Comments 195, 196, 197, 198: Link Sync State Diagram

G. Zimmerman / CME Consulting

2/25/2026

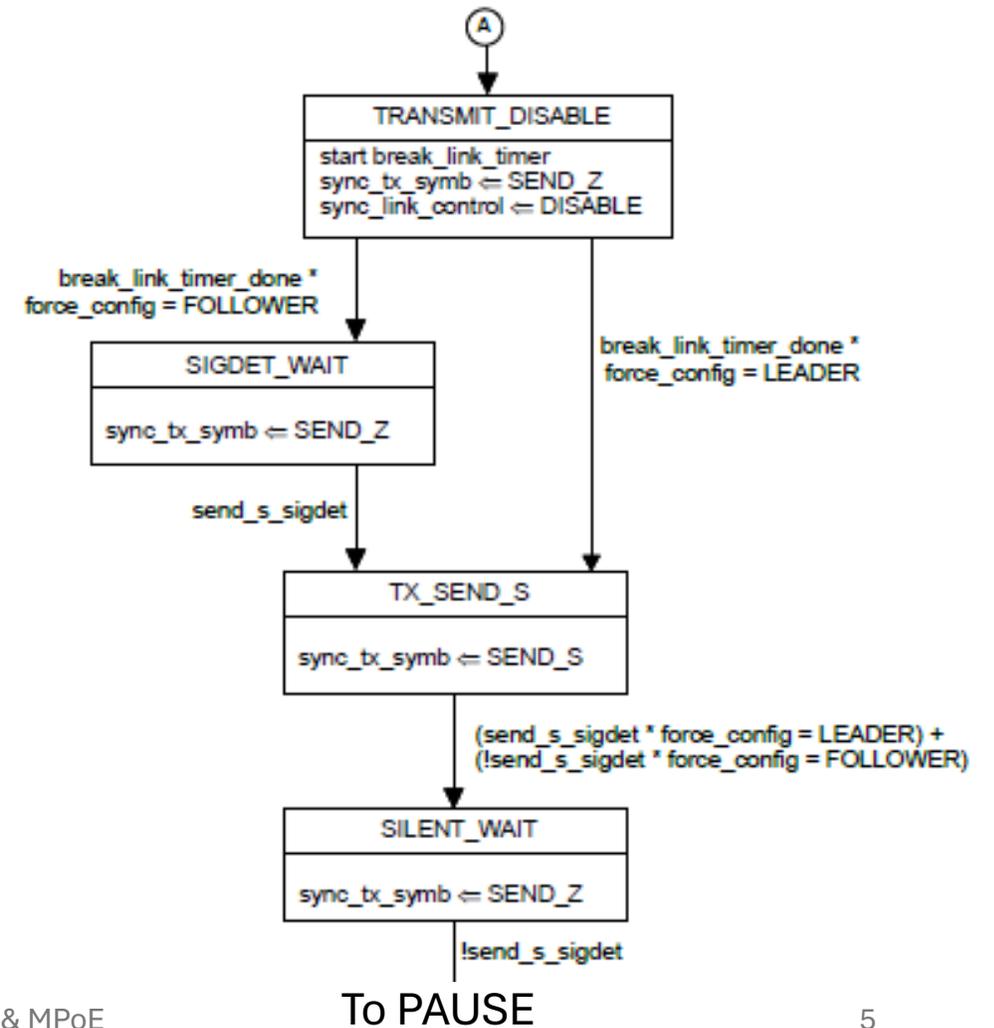
ID	Commenter	CommenterCo	Subclause	Page	Line	Comment	SuggestedRemedy	
195	Zimmerman, George	CME Consulting/ADI,APL Gp, Cisco, Infineon, OnSemi, Sony	201.5.2.10	120	4	This section describes the link synchronization, but lacks the simple requirement that the state diagram (Figure 201-26) shall be followed.	Change "shall establish the start of PHY PMA training as defined in 201.5.2.7." to "shall conform to the state diagram in Figure 201-26. This section describes and defines the function of Figure 201-26, the link synchronization process."	
197	Zimmerman, George	CME Consulting/ADI,APL Gp, Cisco, Infineon, OnSemi, Sony	201.5.2.10	120	40	The 5th paragraph here has shalls which duplicate what is in the state diagram. They should be replaced by descriptive text.	Replace "shall output" at lines 42 and 44 with "outputs" Replace "shall repeat" at line 45 with "repeats" Replace "shall stop outputting and enter" at lines 46-47 with "stops outputting and enters" Replace "shall also enter" at line 48 with "enters"

196	Zimmerman, George	CME Consulting/ADI,APL Gp, Cisco, Infineon, OnSemi, Sony	201.5.2.10	120	41	The text here includes a delay for the FOLLOWER sending out a SEND_S pulse that conflicts with the state diagram. Assuming this is the intended behavior, the state diagram needs to be corrected.	SEE THIS PRESENTATION	
198	Zimmerman, George	CME Consulting/ADI,APL Gp, Cisco, Infineon, OnSemi, Sony	201.5.2.10	.1	122	1	The conditions for what TRUE and FALSE mean are contained as 'shalls' in the variable description for send_s_sigdet. Since the state diagram is one 'shall' this makes it a redundant requirement, and isn't good style.	Delete Text (2 sentences) from "At least 3 consecutive... to "setting this variable from TRUE to FALSE". Change definitions of TRUE and FALSE to: TRUE: At least 3 consecutive valid SEND_S pulses have been detected. FALSE: No SEND_S pulses have been detected for at least 3.1 us.

ID	Commenter	Affiliation	Subclause	Page	Line	Comment	SuggestedRemedy
115	Jonsson, Ragnar	Infineon	201.5.2.10.1	122		The description "At least 3.1µs period with no SEND_S pulses detected shall be detected before setting this variable from TRUE to FALSE" can lead to the state machine staying erroneously in the SEND_S state, in the presence of EMI pulses.	Change "At least 3.1µs period with no SEND_S pulses detected shall be detected before setting this variable from TRUE to FALSE" to "If less than three pulses are detected within a 5.1us period, the send_s_sigdet transitions from TRUE to FALSE"

Comment 115

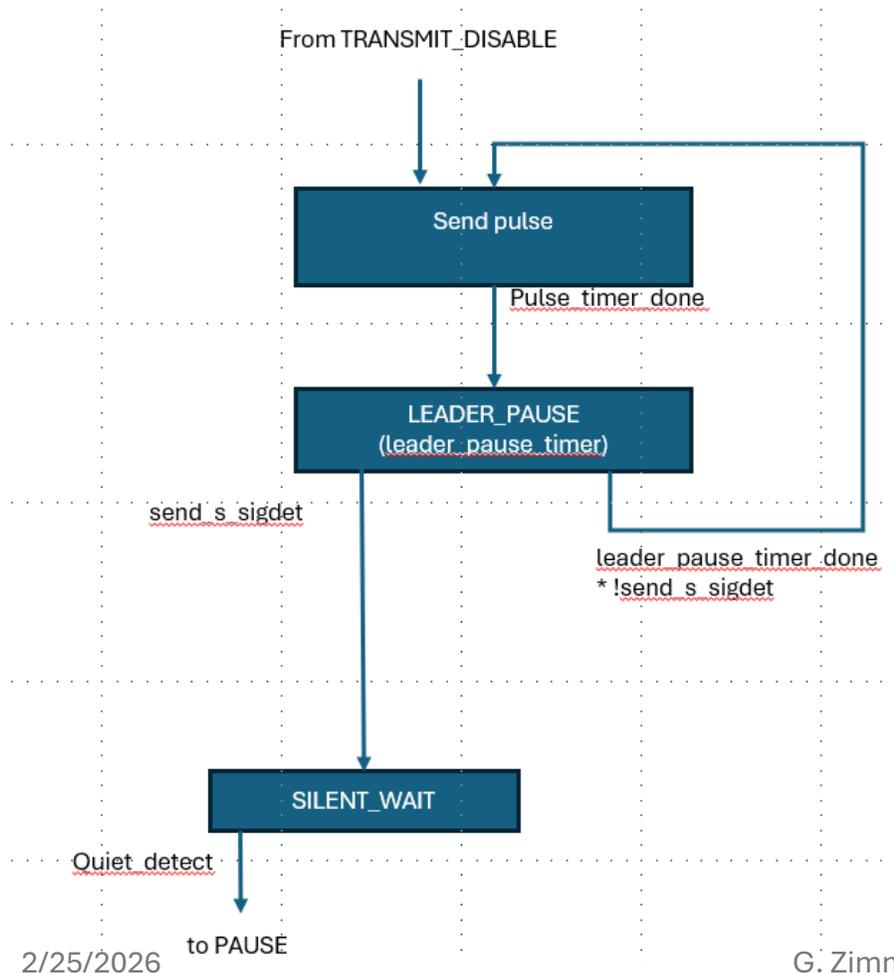
- Comment 115 changes the transition condition for detecting that the link partner has transitioned to SEND_Z to detecting a specific number of pulses within a specific time.
- This removes the issue where a single missed pulse can cause a link partner to advance to the next state (or fall through a state)
- The suggested resolution of comment 115 is incorporated into the solution proposed here

Figure 201–26—PHY Link Synchronization state diagram

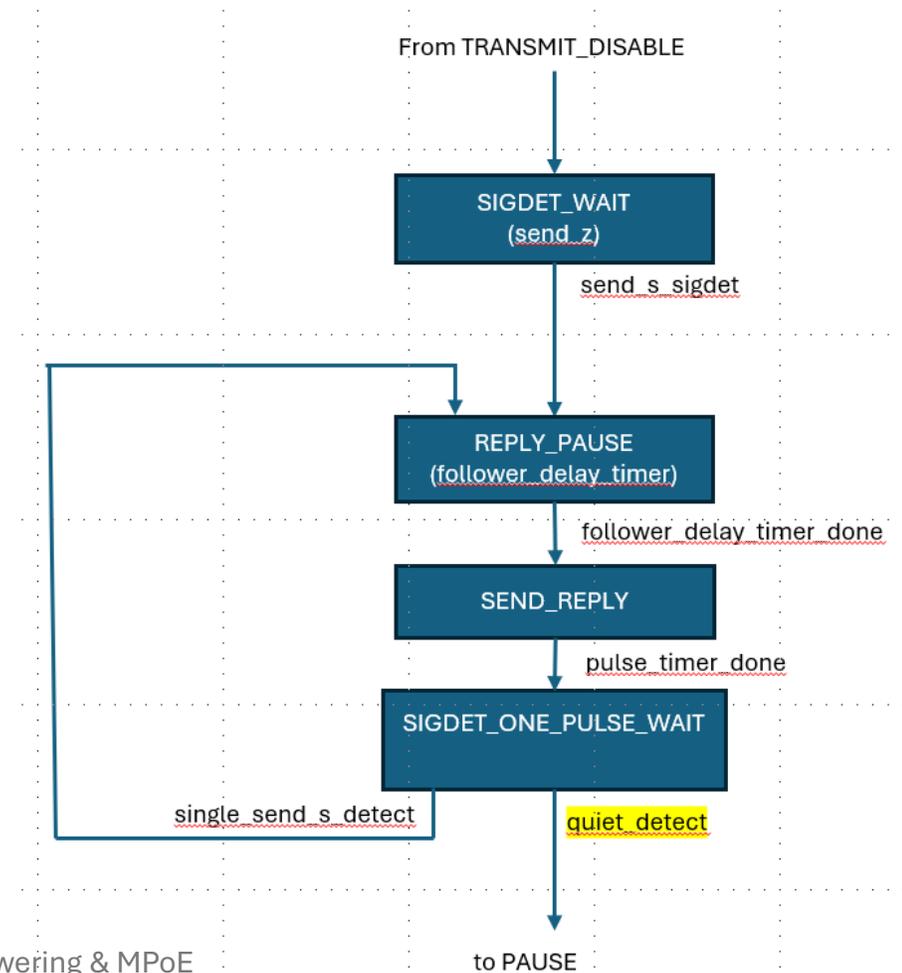
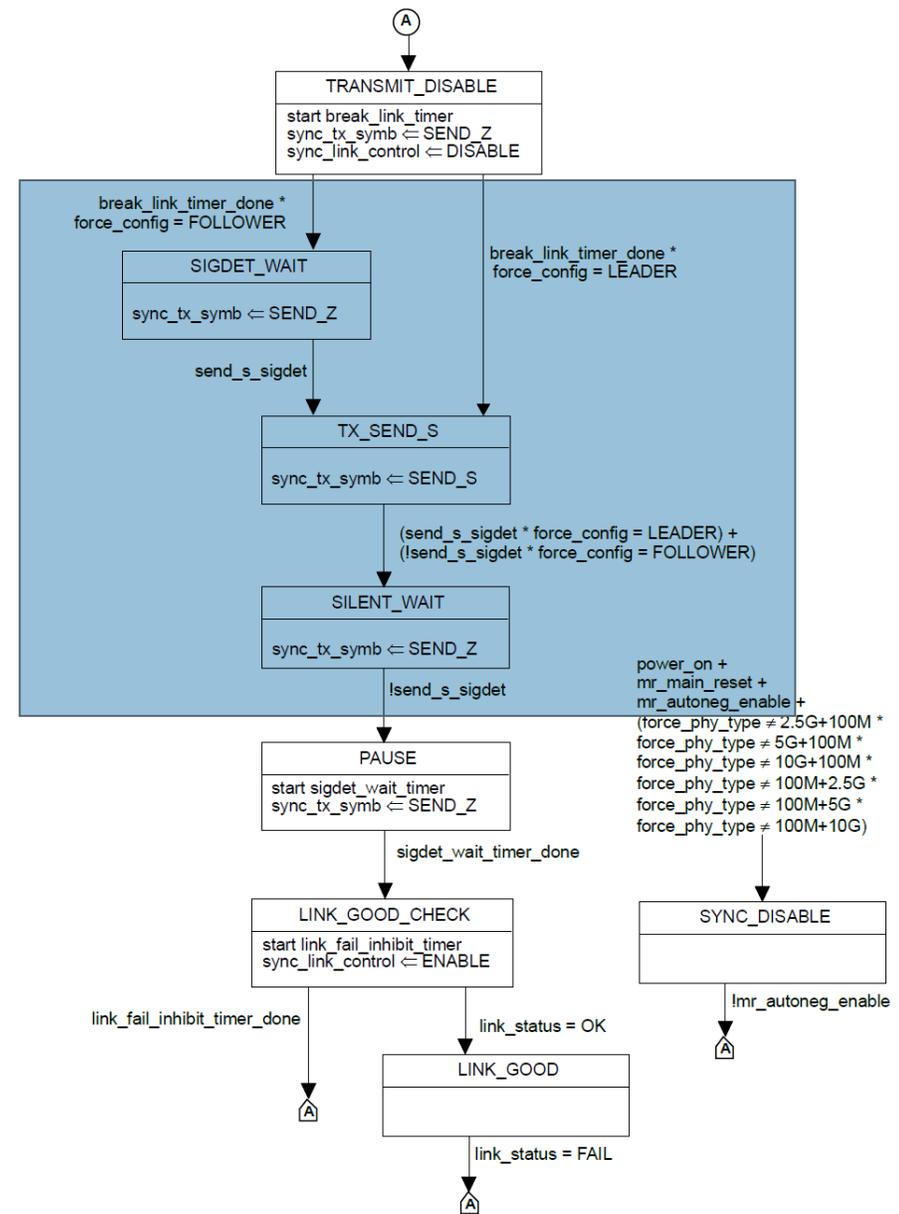
- 201.5.2.10 contains both a textual description of the Link Sync Process and the formal description of the State Diagram
 - They do not describe the same behaviour for the progress of detecting the link_sync until entry to PAUSE
- The text describes its behavior with “shalls”, which are duplicative of the state diagram’s requirements
- SEND_S is described both as a pulse and as a periodic pulse train
 - The use is different for the LEADER and the FOLLOWER...
- The behavior of the key variable, send_s_sigdet, is defined to be dependent on it’s state – mixing definition and state diagram

- Leader sends SEND_S with each transmit clock
 - No mention of silence then repeating, is SEND_S a pulse or a sequence of pulses?
 - Comment 113 would have “SEND_S signal” & “SEND_S pulse”
- Follower silently waits to detect 3 consecutive SEND_S pulses
- Follower then begins sending SEND_S
 - Overrides delay mentioned in text, and if SEND_S is a sequence of pulses, this differs from text
- When Leader detects 3 consecutive SEND_S pulses, enters SILENT_WAIT state & goes silent
- When Follower misses the first SEND_S pulse from the Leader, it enters SILENT_WAIT and goes silent
- Follower will fall straight through SILENT_WAIT to PAUSE
- Leader will proceed to PAUSE when it misses it’s first Follower SEND_S pulse

- I believe we want the behavior in the text, particularly
 - Follower first detects ‘a sufficient number’ of Leader pulses
 - Follower responds with a single pulse to each subsequent pulse from the Leader, pulse by pulse
 - SEND_S signal detections (send_s_sigdet) is more robust than just consecutive pulses – “a sufficient number”
 - Detecting silence from the partner is more robust than missing a single pulse
- This means:
 - SEND_S is a pulse (contrary to comment 113)
 - The state diagram needs to generate the periodic pulse train at the Leader
 - We either need a new variable to detect silence, or else states in the diagram to describe the behavior of send_s_sigdet

- Add a new variable for detecting silence (incorporating comment 115) & modify send_s_sigdet
 - **quiet_detect**: A Boolean variable that indicates whether the link partner has ceased sending SEND_S pulses.
VALUES:
TRUE: Fewer than three SEND_S pulses have been detected at the specified times (for LEADER or FOLLOWER see Figure 201-25) within the preceding 5.1 usec.
FALSE: Three or more send_s pulses have been detected at the specified times (for LEADER or FOLLOWER see Figure 201-25) within the preceding 5.1 usec

- **send_s_sigdet**: A Boolean variable indicating whether sufficient SEND_S pulses have been detected. The definition of a sufficient number of pulses is implementation dependent.
VALUES:
TRUE: Sufficient SEND_S pulses have been detected
FALSE: Sufficient SEND_S pulses have not been detected

- Other new variables: single_send_s_detect
- Add new timers: follower_delay_timer, leader_pause_timer, pulse_timer
- Delete “shalls” in the descriptive text of 201.5.2.10

These two state chains go (as parallel vertical branches) replacing the states in the blue square in the PHY Link Synchronization state diagram at right.
